**ISSUE:** Permit to Demolish/Capsulate (partial) and Certificate of Appropriateness

**APPLICANT:** 214 and 216 S Payne St LLC

214/216 South Payne Street

Docket #7 & 8 BAR #2021-00134 & 2021-00355 (B) Old and Historic Alexandria District September 16, 2021

Figure 1: Plan showing location of small addition on south elevation

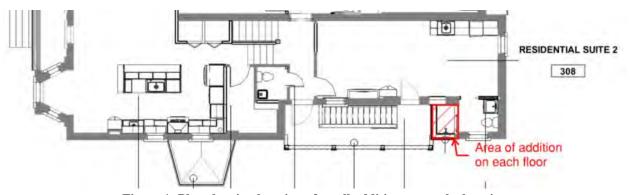
The applicant proposes to construct two additions to the existing building. A small addition to the east end of the existing notch at the south side of the building will house an extension of a bathroom and is proposed to be clad in a light-colored thin stone veneer (Figure 1).

In the current configuration, the existing building features a notch in the masonry footprint in the rear half of the south elevation that is infilled with a decorative wood porch and exterior stair to provide access to the upper levels from the side yard. The applicant is proposing to remove the existing porch and stair and replace it with a new one of similar design but protruding from the face of the building by approximately 1'-6" in order to allow enough room on each level of the porch for it to be occupiable along with the stair. The applicant is also proposing to reduce the overall length of the notch by approximately 3'-6" by increasing the masonry footprint on the east end to allow for a shower on the interior (Figure 4). In response to Board comments, the applicant has revised the cladding of the addition to distinguish it from the existing adjacent painted brick. The applicant is proposing a light-colored thin stone veneer for the cladding. Staff is concerned that this may be too different than the adjacent brick and will be incompatible with the rest of the elevation. One potential option would be to use an unpainted brick similar in color to the adjacent painted brick. This would give the elevation a uniform look while the area is still clearly identifiable as a later addition. Staff finds that the proposed modifications to the south elevation do not significantly change the character of the building or remove important or unique historic fabric and supports the approval of the Certificate of Appropriateness for the work on this elevation, with the condition that the applicant work with staff on the cladding material selection.

- 1. The applicant work with staff to determine an appropriate material for the cladding of the small addition at the east side of the notch on the south elevation.
- 2. The applicant work with staff on connections between the proposed exterior stair on the rear (east) elevation and the existing historic masonry wall to minimize the impact of these connections on the masonry.
